UNITED STATES PATENT AND TRADEMARK OFFICE

APPLICATION NO.	FILING DATE	FIRST NAMED INVENTOR	ATTORNEY DOCKET NO.	CONFIRMATION NO.
10/537,625	06/03/2005	Joanne Joy Smith	1926-00106	5466
26753	7590	07/23/2007		
ANDRUS, SCEALES, STARKE & SAWALL, LLP 100 EAST WISCONSIN AVENUE, SUITE 1100 MILWAUKEE, WI 53202			EXAMINER BARLOW, MONICA L	
			ART UNIT	PAPER NUMBER
			3609	
			MAIL DATE	DELIVERY MODE
			07/23/2007	PAPER

Office Action Summary	Application No.	Applicant(s)	
	10/537,625	SMITH, JOANNE JOY	
	Examiner	Art Unit	
	Monica L. Barlow	3609

DETAILED ACTION

FIG 2

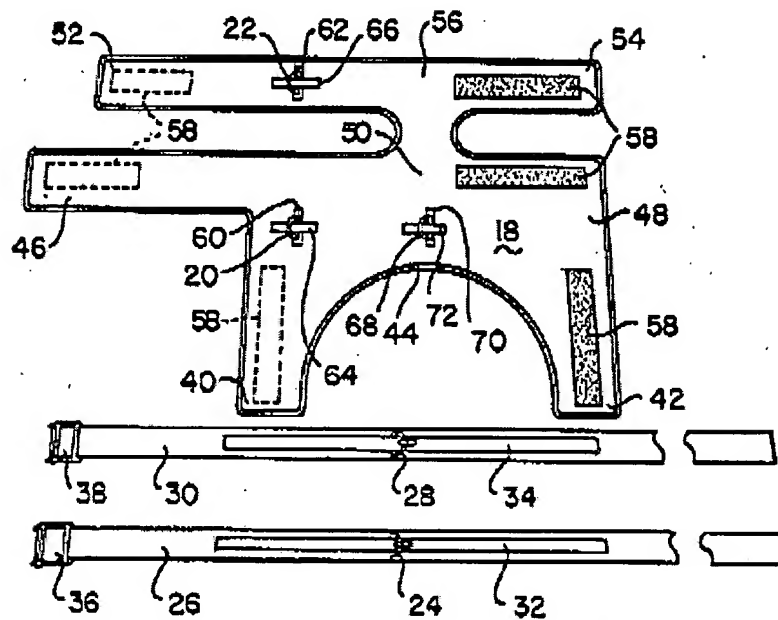
7. In re claim 17, with reference to Figure 2 shown below, Friedman discloses an animal safety restraint for vehicles with a neck strap, a body strap with two fixing points (20, 22) between the chest and spine strap adapted for attachment to a vehicle seat by a pair of linkages (26, 30), each having a first end (24, 28) adapted to engage with a fixing point and a second end (36, 38) adapted for attachment to a seat, a spine strap with a further fixing point and a chest strap both connecting the neck and body strap.

9. In re claims 21-23 and 27, with reference to Figure 2, Friedman discloses the neck strap and the body strap each have two free ends each end having complementary engagement means being a quick release clasp (58) to fasten around the animal's neck and body, where the fixing points are adjacent to the engagement means on the body strap.

10. In re claims 28 and 29, with reference to Figure 2, Friedman discloses each strap of the harness to be adjustable using the engagement means (58).

11. In re claim 31, with reference to Figure 2, Friedman discloses each fixing point is a metal ring.
